PLANNING REVIEW CHECKLIST

Subject Property: 1035 Commercial Street SE and 160 Bush Street S
Ref#: 23-101981-PLN (Class 3 Design Review and Class 2 Adjustment)

A consolidated application for a Class 3 Design Review and Class 2 Adjustment was received on January 19, 2023, for property located at 1035 Commercial Street SE and 160 Bush Street S.

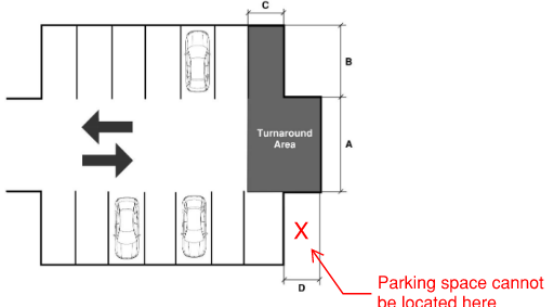
<p>Vehicle Use Area Setback</p>	<p>SRC 806.035(c)(2) provides the minimum setback adjacent to a street is 10 feet, however, the setback may be reduced to six feet as provided by SRC 806.035(c)(2)(D). The applicant indicates that method D will be used, including a minimum three-foot-tall wall between the vehicle use area and Commercial Street SE, however, the application materials indicate the use of a six-foot tall fence.</p> <p>Please clarify. An adjustment may be needed to reduce the vehicle use area setback if the requirements of Method D cannot be meet.</p>										
<p>Off-Street Parking, Loading, and Driveways – SRC Chapter 806 – Interior Parking Area Landscaping</p>	<p>The proposed site plan does not appear to comply with the minimum interior landscape. An approximate calculation indicates 12,760 square feet of parking area and 415 square feet of interior landscape area (3.2%), less than the minimum required. Please clarify how the minimum interior landscape for the site was determined.</p> <div style="text-align: center;">  <p>LANDSCAPE PLAN SCALE: 1" = 20'-0"</p> <p>PLANT SCHEDULE</p> <p>TREES</p> <ul style="list-style-type: none"> T1: WHITE BARK T2: REDWOOD COLUMNAR FORM T3: REDWOOD T4: BIG LEAF MAPLE <p>SHRUB OPTIONS (TBD)</p> <ul style="list-style-type: none"> S1: BLUE ANGELO S2: BLUE OAT S3: LAUREL S4: SUBSPICUOUS S5: BURNING S6: LAUREL S7: PACIFIC GARDEN S8: WESTERN GARDEN S9: NEW GARDEN S10: LAUREL <p>INTERIOR LANDSCAPING</p>

<p>COZY RESIDENTIAL 1035 COMMERCIAL ST SE SALEM, OR 97302</p> <p>SP-3 DATE: 03.18.2021</p> </div>	TYPE	AREA	INTERIOR OFF STREET PARKING	12,766.27	INTERIOR LANDSCAPING	415	TOTAL INTERIOR LANDSCAPING REQUIRED BY SRC CHAPTER 806	12,766.27	STREET PARKING AREA IS 12,766.27	12,766.27
TYPE	AREA										
INTERIOR OFF STREET PARKING	12,766.27										
INTERIOR LANDSCAPING	415										
TOTAL INTERIOR LANDSCAPING REQUIRED BY SRC CHAPTER 806	12,766.27										
STREET PARKING AREA IS 12,766.27	12,766.27										
<p>Off-Street Parking, Loading, and Driveways – SRC Chapter 806 – Off-Street Parking Area Access and Maneuvering</p>	<p>The proposed vehicle use area does not comply with the turnaround requirement in SRC 806.035(f), Figure 806-9. Please revise the layout to comply with the requirements of SRC Chapter 806.</p>
